June 8, 1982

SUBJECT: Grand Gulf Nuclear Station
Units 1 and 2
Docket Nos. 50-416 and 50-417
File 0260/L-814.2
SQRT - Additional Information
Supporting Justification for
Interim Operation
AECM-82/254

Grand Gulf SQRT Program
Justification for Interim Operation Summary

GRAND GULF NUCLEAR STATION
UNIT 1
SUPPORTING ANALYSIS REPORT ON THE
JUSTIFICATION FOR
INTERIM OPERATION OF THE RHR
HEAT EXCHANGER

LOWER VALVE SUPPORT DETAIL

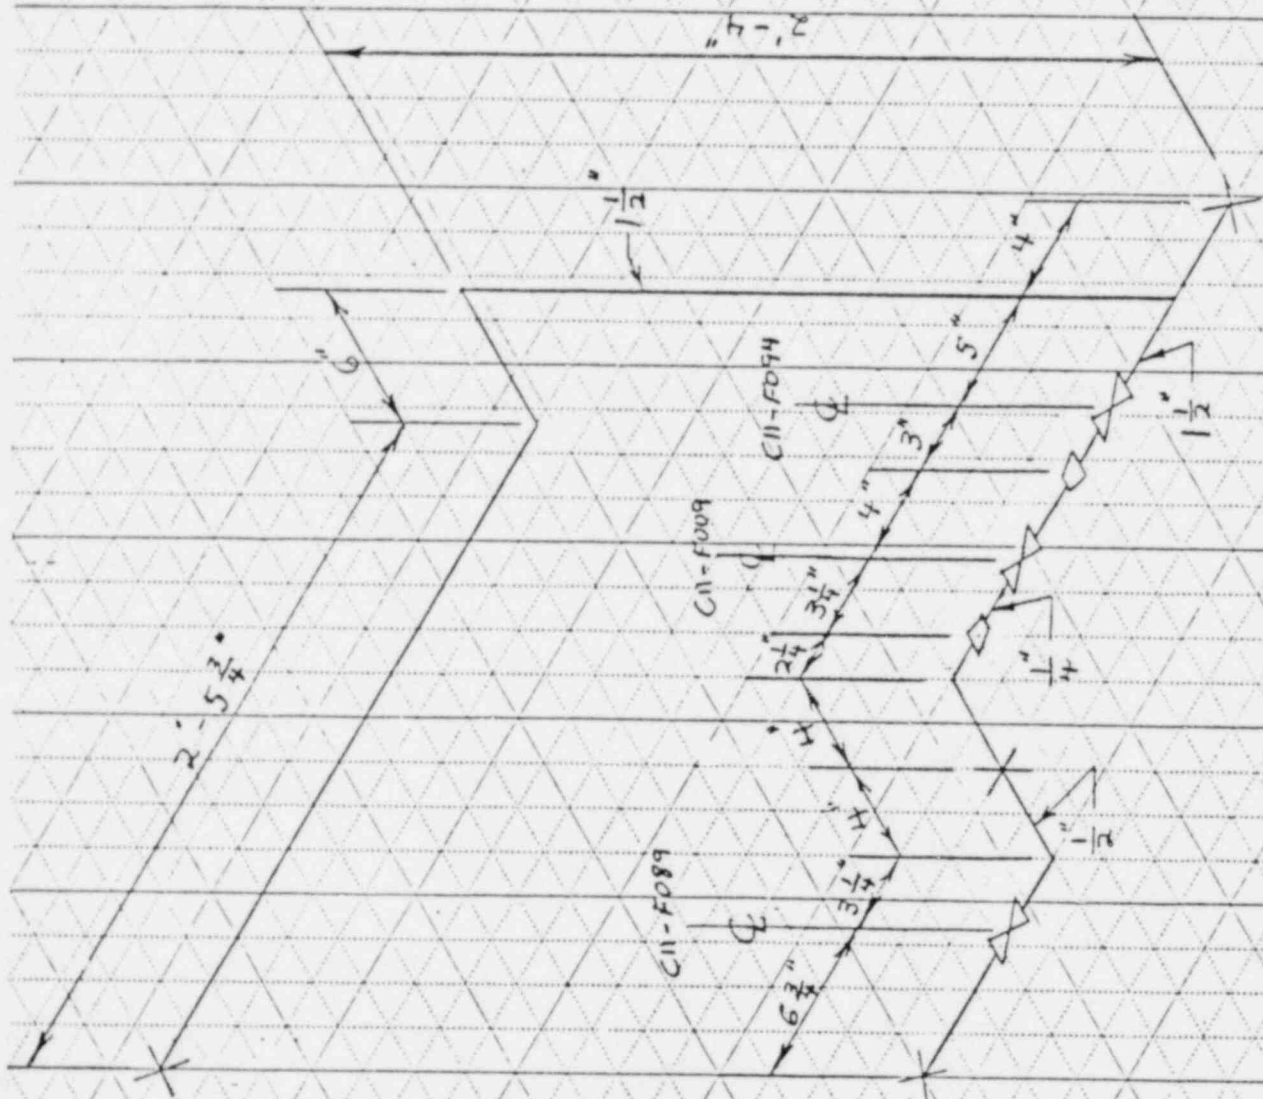
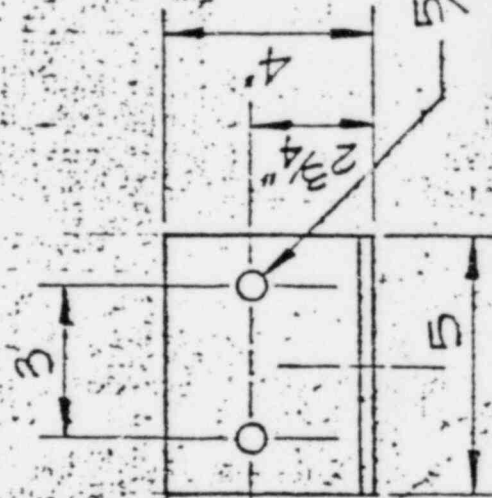
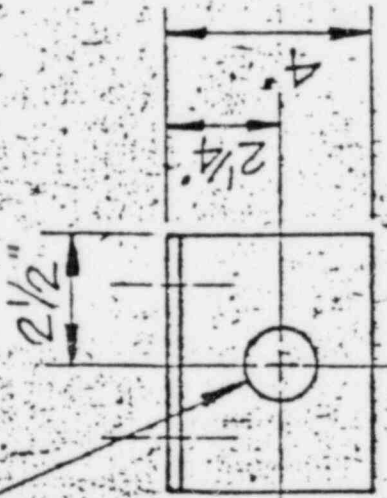
PER OUR DISCUSSION, HERE IS THE INFORMATION ON THE CRD SOLENOID VALVE (C11-F009). THE EXISTING FIELD CONFIGURATION HAS BEEN DUPLICATED ON THE ATTACHED ISOMETRIC DRAWING. ALL SUPPORTS ARE DESIGNATED BY AN "X". THE VALIDITY OF THE ASSUMPTION THAT THE U-BOLTS WERE 3-D SUPPORTS HAS BEEN RESOLVED AS RECENT FIELD MODIFICATIONS HAVE ADDED SPACERS. ALL SUPPORTS SHOWN MAY BE ASSUMED TO BE 3-D. A $6\frac{1}{2}$ " LONG CONDUIT EXTENDS HORIZONTAL FROM C11-F009. FLEX CONDUIT RUNS FROM THIS TO RIGID STEEL CONDUIT LOCATED APPROXIMATELY 5' ABOVE THE VALVE. THE R.S. CONDUIT IS SUPPORTED AT THIS POINT. A $9\frac{1}{2}$ " LONG CONDUIT EXTENDS VERTICAL FROM C11-F009 AND IS SUPPORTED BY A 3-D CLAMP. THIS SUPPORT IS NOT SHOWN ON THE ISOMETRIC DRAWING BUT SHOULD BE TAKEN INTO ACCOUNT DURING YOUR ANALYSIS. A DETAIL OF THIS SUPPORT STRUCTURE IS ALSO ATTACHED. I WILL CONTACT YOU MONDAY MORNING TO DISCUSS THIS INFORMATION. IF THIS CONFLICTS WITH YOUR SCHEDULE, PLEASE CONTACT ME AT X 2873.

This valve installation, which was apparently designed by RCI, differs greatly from what we have used in a similar application (see Drawing J0134S). The J0134S installation clearly shows the valve rigidly supported in two directions. However, the geometry of the 1C11-SV-F009 installation is not so well defined. Therefore, your evaluation should closely examine the assumption that the valve is restrained in two directions.

THE RESULTS SHOW ZERO ACCELERATION ON THE VALVE. THIS MEANS THAT VALVE MOVES WITH THE SUPPORT STEEL WHICH IS ASSUMED TO BE RIGIDLY ATTACHED TO THE FLOOR STEEL, WHICH MOVES WITH THE FLOOR. THEREFORE THE VALVE WILL ONLY SEE THE ACCELERATIONS THAT THE FLOOR WILL SEE.
